## CONSERVATION TEAM CONSULTATION APPLICATION RESPONSE

| <b>APPLICATION REF:</b>      | 26/01308/FPH & 26/01309/LBC                                                                                                                                                                                                                                                                                                                                                                                                                                                |
| <b>APPLICATION SITE:</b>     | The Bull, High Street, Gosmore, Hertfordshire, SG4 7QG                                                                                                                                                                                                                                                                                                                                                                                                                     |

REAR ELEVATION

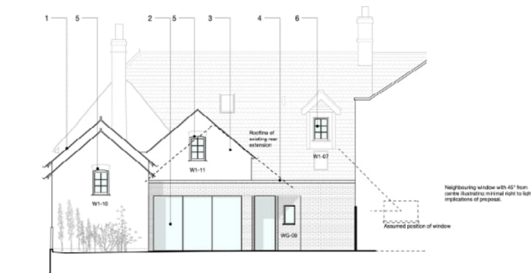
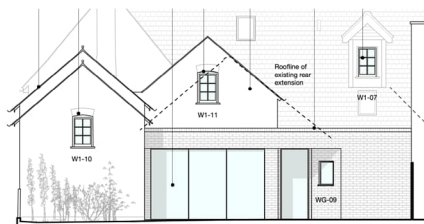
Furthermore, during the pre-application process whilst I raised no objection to a taller, well-proportioned central gable I was less convinced by the predominantly glazed gable treatment and I suggested an alternative approach.

Attention then turned to the potential of removing the vaulted gable ceiling to the later, central addition and replacing this with a flat roof, thus, more fully revealing the rear of the original listed building. This would allow the potential to introduce a window to the gable end of the new bathroom. The flat roof concept has been taken on board and although a contemporary intervention is considered acceptable.

I have two questions at this point:

1. Is the rear central gable proposed to be covered with slate or clay tile – preference is for the latter – see draft Condition 3?
2. What is the proposed facing brickwork to the flat roof extension – red brick, gault brick, painted brick?

3. The roof of the central rear gable shall be covered with clay tiles, a sample or details of which shall be submitted to and approved in writing by the Local Planning Authority prior to the commencement of that part of the alterations hereby consented. Thereafter the roof shall be covered in accordance with the approved materials

5. If the single-storey flat-roof rear addition is to be finished with facing brickwork, then details or samples of the facing brick including bond shall be submitted to and approved in writing by the Local Planning Authority prior to the commencement of that part of the alterations hereby consented. Thereafter the brickwork shall be undertaken in accordance with the approved materials. If the brickwork is proposed to be painted, then details of the brick bond and paint colour shall be submitted to and approved in writing by the Local Planning Authority prior to the commencement of that part of the alterations hereby consented. Thereafter the brickwork shall be painted in accordance with the approved colour.
